April 27, 2021

**NOTICE OF ADDENDUM
ADDENDUM NO. 2
CONTRACT NO. 8576**

**NORTH BROOKS STREET, FAHRENBROOK COURT AND COLLEGE COURT RESURFACING
ASSESSMENT DISTRICT - 2021**

MARK	DATE	BY
ADDENDUM 2	4/26/21	DAO
REVISION	DATE	BY
13180	4/26/2021 3:55 PM	U-6

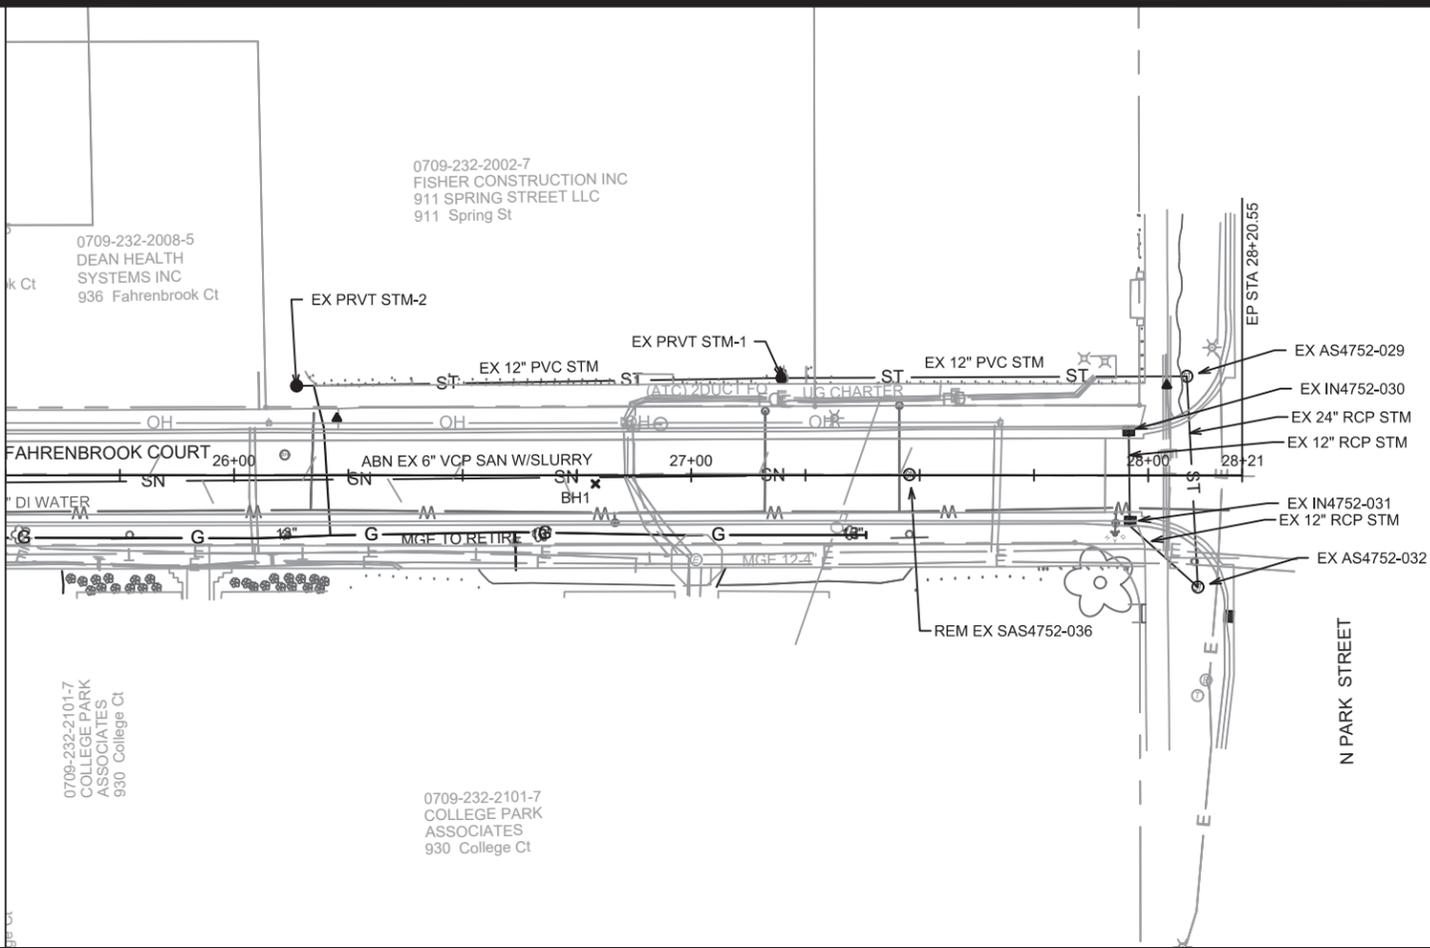
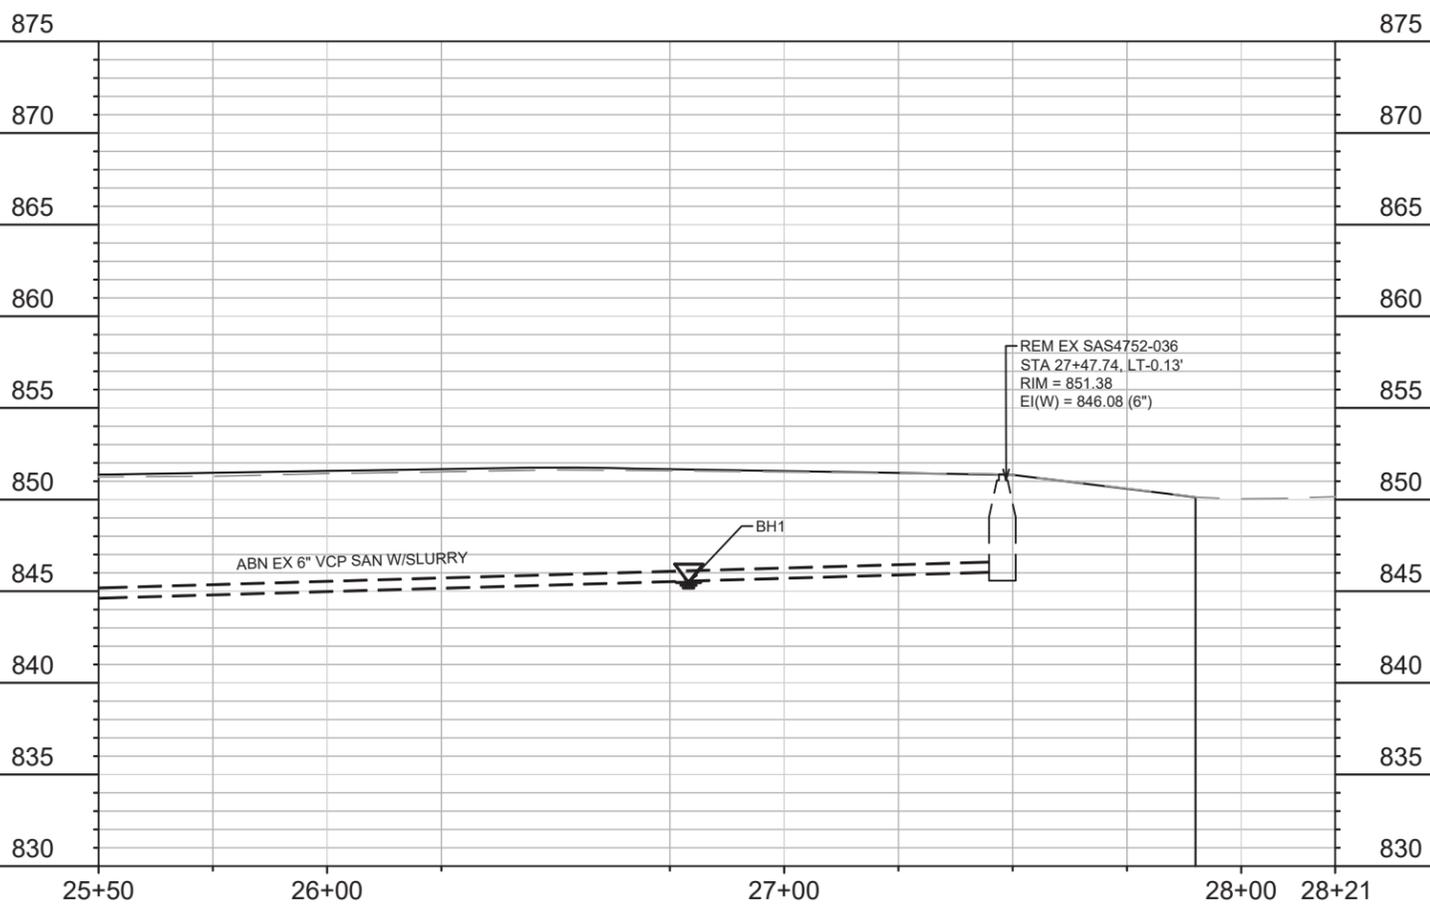
Remove and replace attached page U-1 to U-8: Updated plans with revised sanitary sewer layout.

ALL PROPOSED
SANITARY HAS BEEN
CHANGED FOR
ADDENDUM 2
